Howard County Health Department
Bureau of Environmental Health
3525-H Ellicott Mills Drive
Ellicott City, Maryland 21043

Reference: Proposed residence
3925 Old Rolling Road, Shepherd's Glen, 3rd Election District
Howard County, Ellicott City, Maryland 21043

January 3, 1995

Re: Proposed residence
Shepherd's Glen
3925 Old Rolling Road
Ellicott City, Maryland 21043

SITE PLAN

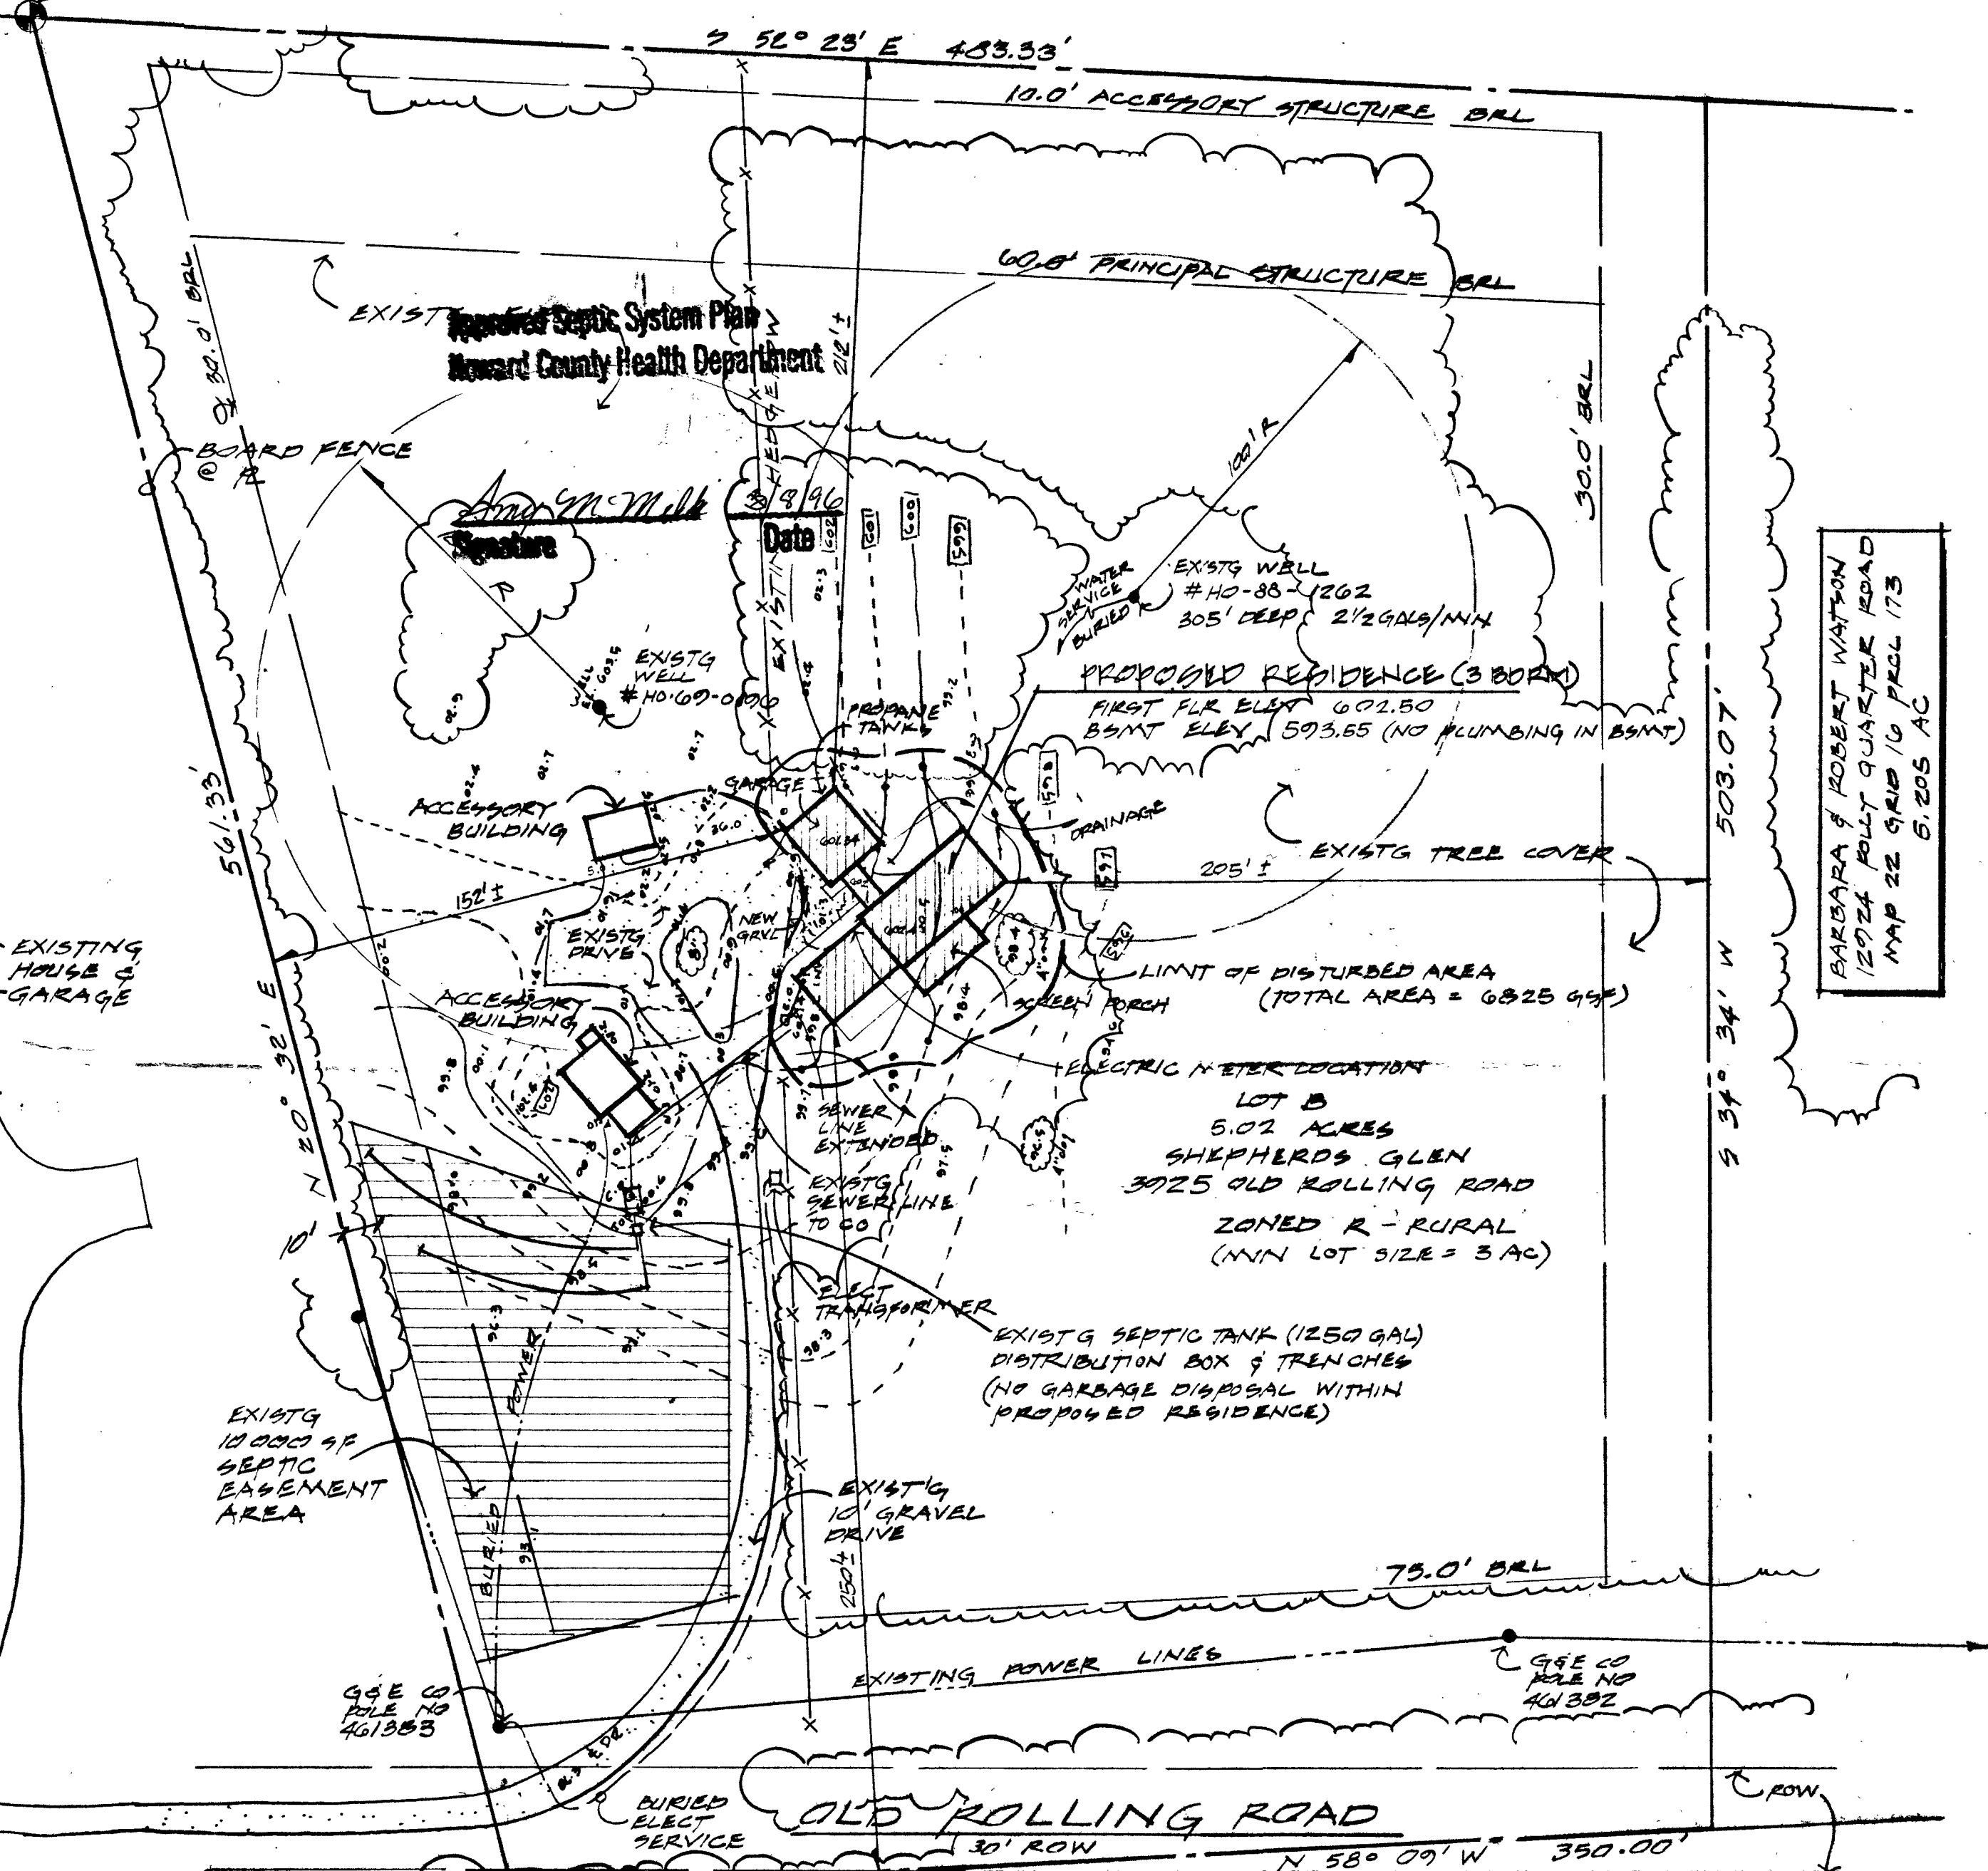
This office has the following concerns with the above referenced proposal:

1. Frank Skinner agreed to the hook-up of an additional 2 bedroom home, the proposal is for a 3 bedroom home.
2. Current preferred practices for a new single family dwelling are to have a recorded 10,000 square foot sewage disposal area for each dwelling unit on a property. At present there is no recorded sewage disposal easement.

3. Our records indicate that there were 2 percolation test holes dug on May 1969 and one visual hole on October 4, 1982. Due to the location of these test holes, approximately 50% of the sewage area shown on the current proposed plan has not been tested. (It would be preferred that this untested area be tested before the building permit approval.)

4. Our records indicate that well HO-69-0196 is dry. Current policy is that all original wells be abandoned as a condition for approval of a replacement well. Although this was not a requirement at the time of the issuance of replacement well permit HO-88-1262, HO-69-0196 should be abandoned.

5. This office has no record of any satisfactory water test results for well HO-88-1262. For future reference, a satisfactory water sample would be required for use and occupancy approval of the new home.

- 1) Because septic capacity for a 4bdrm home put in- it is OK to connect new home to existing septic system (going will be requiring the removal of all kitchen equipment from existing 1bdrm home thus it will not be a SFD or apartment) No additional tank will be necessary for new home but it was suggested to A. Fontaine. ~~suggested~~
- 2) It is OK to keep ~~the~~

both wells. But before anything can be approved - Mr Andre Fontaine must send a written request to keep both wells and an assurance to this office that there will be separate plumbing and no cross connections.
